# ARCHITECTURAL REVIEW COMMITTEE MEMORANDUM

DATE: DECEMBER 7, 2021 NEW BUSINESS

SUBJECT: PS PROP CO HOLDING, LLC, FOR A MINOR ARCHITECTURAL APPLICATION FOR AN EXISTING 12,000-SQUARE FOOT COMMERCIAL CENTER TO INCLUDE FAÇADE AND LANDSCAPE IMPROVEMENTS AT THE FORMER SOSSA MARKET SHOPPING CENTER LOCATED AT 3700 EAST VISTA CHINO ROAD, ZONE M-1-P. (CASE 3.3138 MAA)

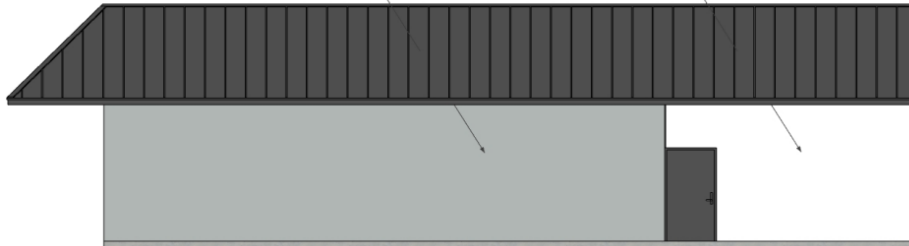
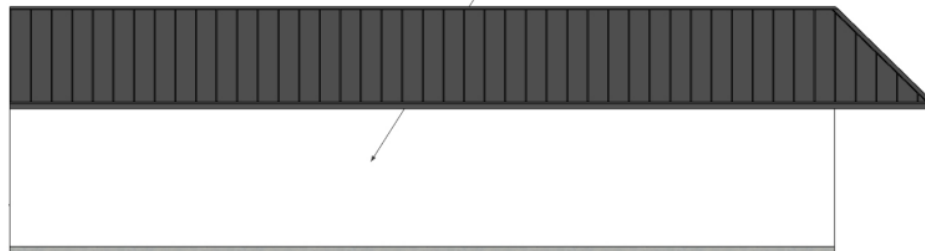
<i>Criteria and Findings [PSZC 94.04.00(E)]</i>	<i>Compliance</i>
1.	<i>The architectural treatment is consistent on all four sides of the proposed building(s), unless otherwise approved by the ARC;</i>	Y
	All sides of the building will be painted according to the proposed paint scheme consisting of white and gray shades.

3.	<i>The façade elements and fenestration are composed in a harmonious manner;</i> The removal of the existing barrel tile mansard roof to be replaced with standing seam metal in a dark gray color will update the look of the center. Other elements of the façade to include a harmonious paint scheme is of good composition.	Y

5.	<i>The proposed color scheme is appropriate to the desert environment and consistent with the site context;</i> The front façade will be painted a combination of white and gray colors with the main body named “Pure White” located on the west front façade; the middle portions will be shade darker called “Site White” and “Ceiling Bright White”; the eastern front façade to be painted “Online” which is a light gray.	Y

**PRELIMINARY LANDSCAPE PLAN**

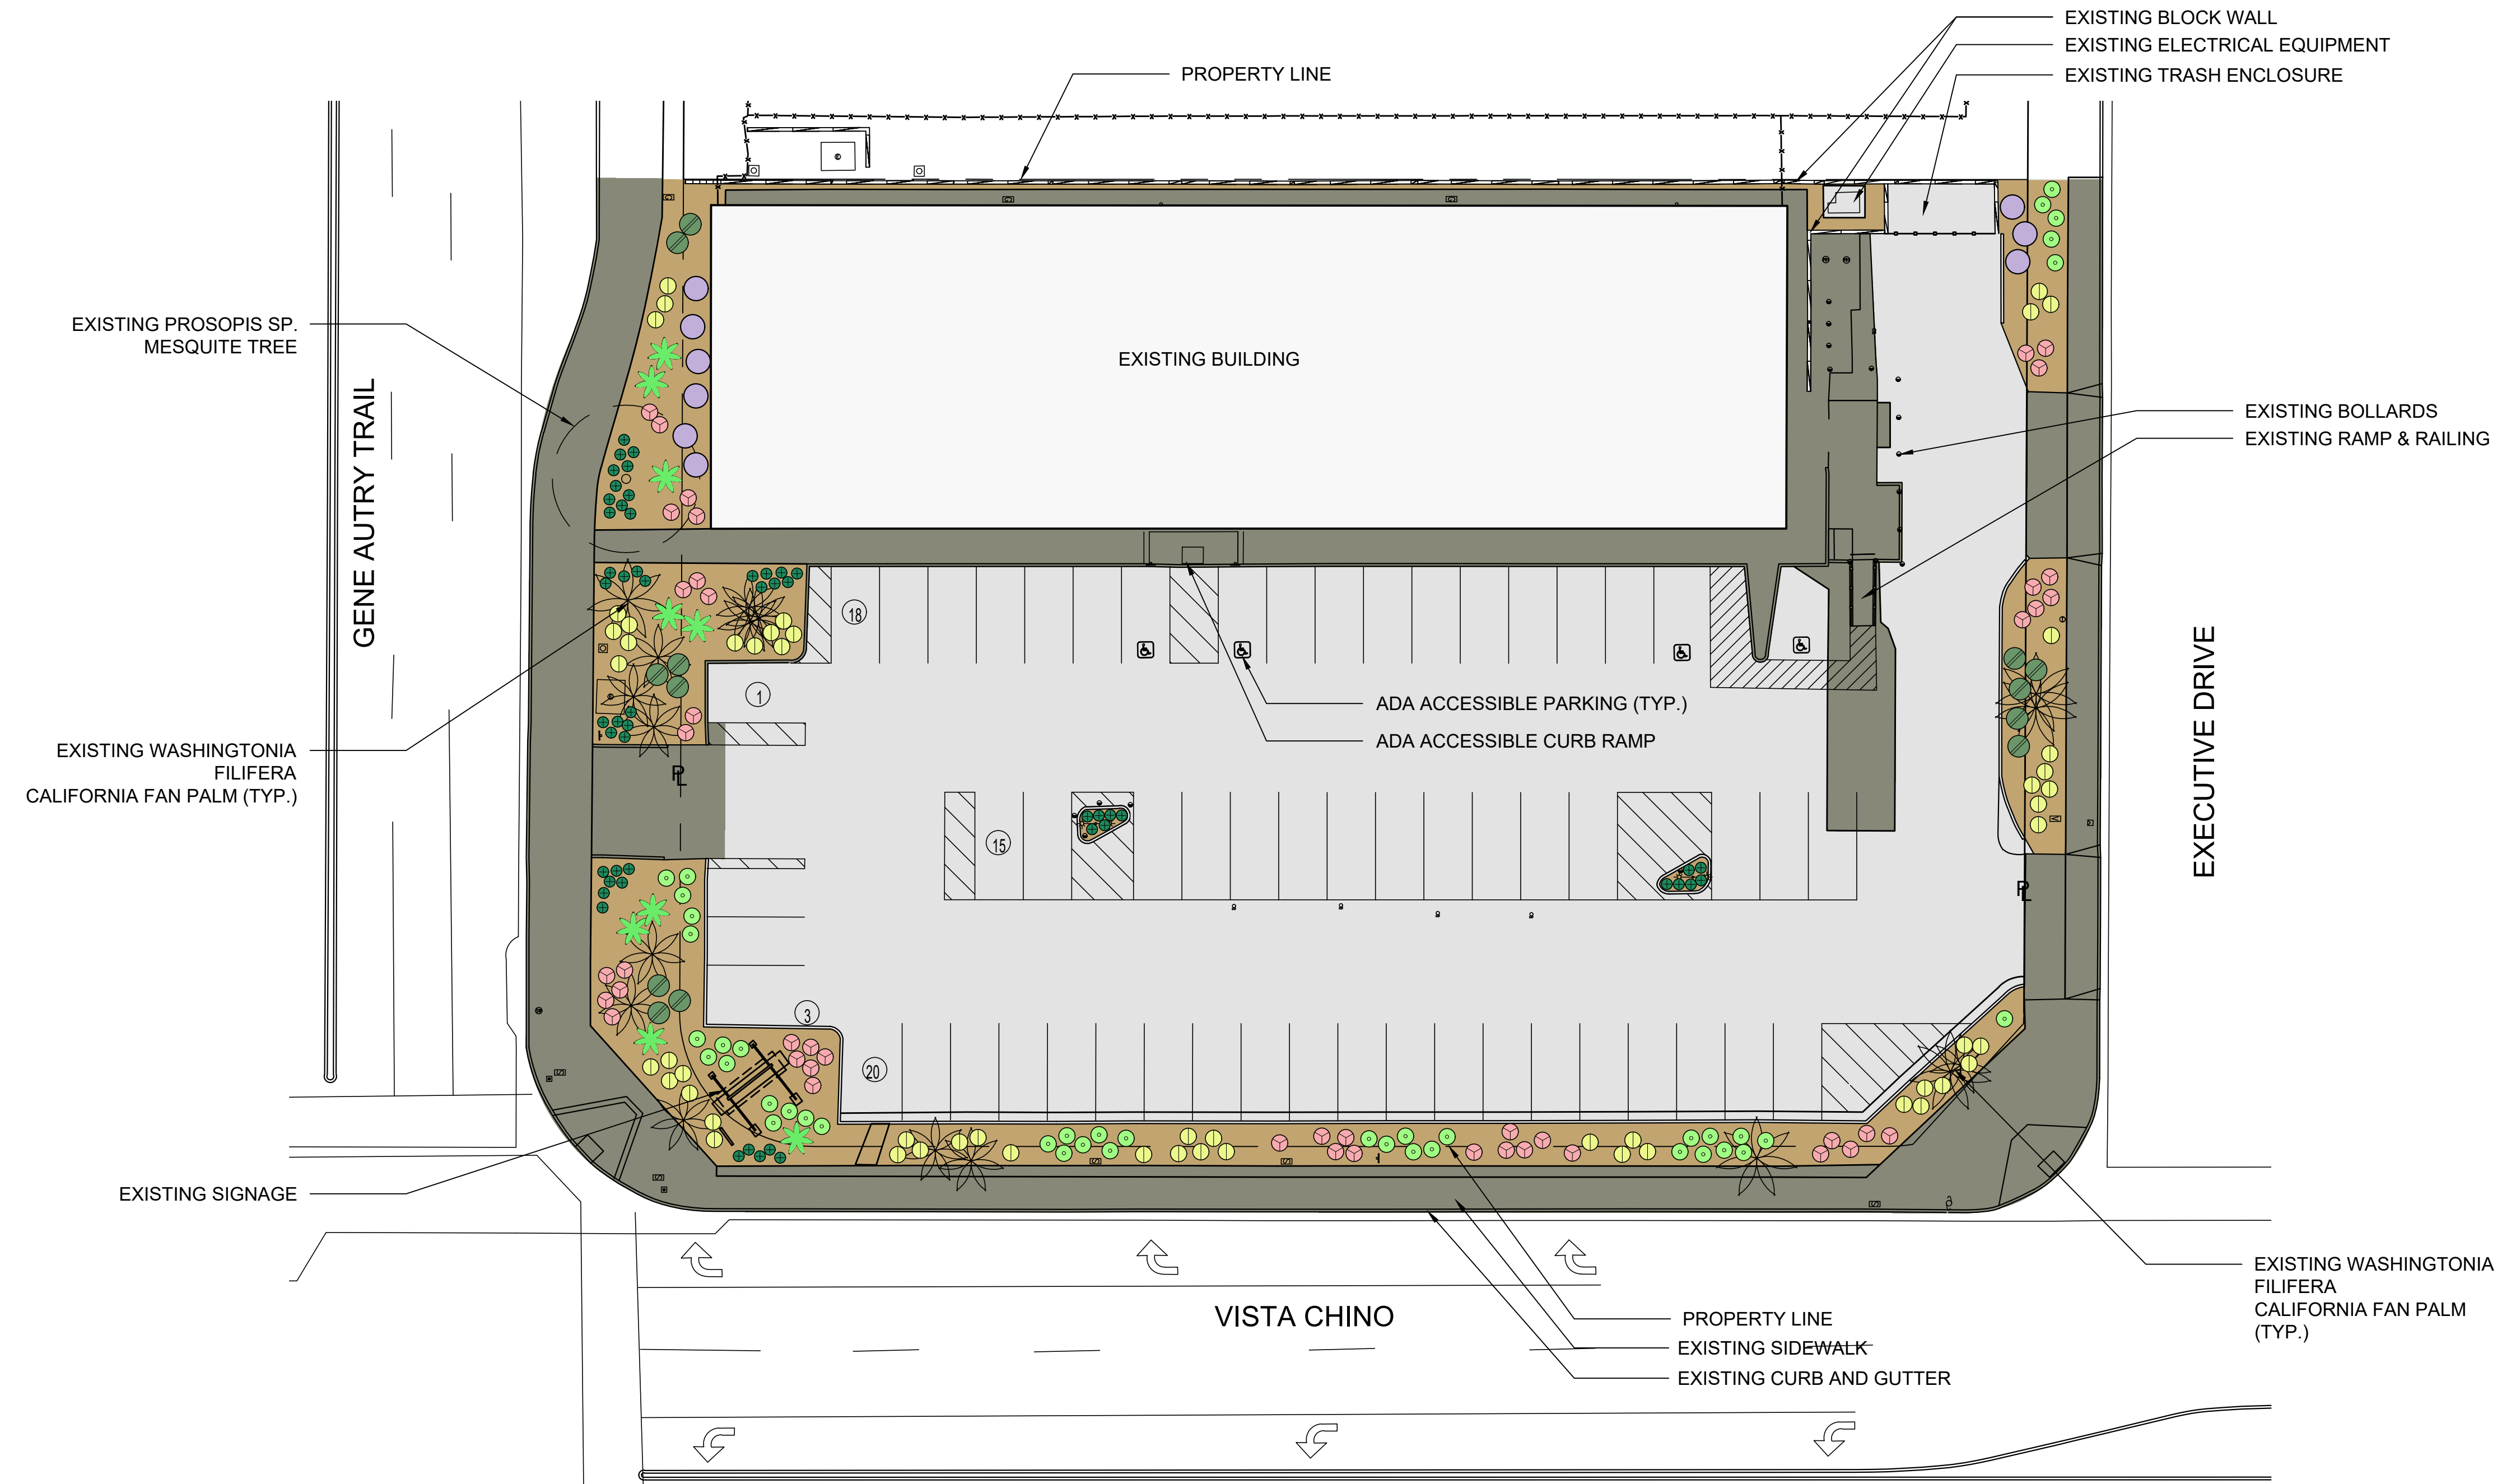
7.	<i>The proposed landscape plan is consistent with the requirements of PSMC Chapter 8.60;</i> The landscape plan shows the existing mature palm trees to remain with the addition of an African Sumac and Palo Verde tree, Bougainville, and Red Yucca. Ground cover will be tan decomposed granite.	Y

8.	<i>The proposed landscape plan is consistent with all applicable zoning requirements, including any streetscape requirements, landscape buffer requirements, and screening requirements;</i> The proposed landscape plan will enhance the overall appearance of the existing shopping center by updating the parking lot perimeter areas with new plants and hardscape.	Y
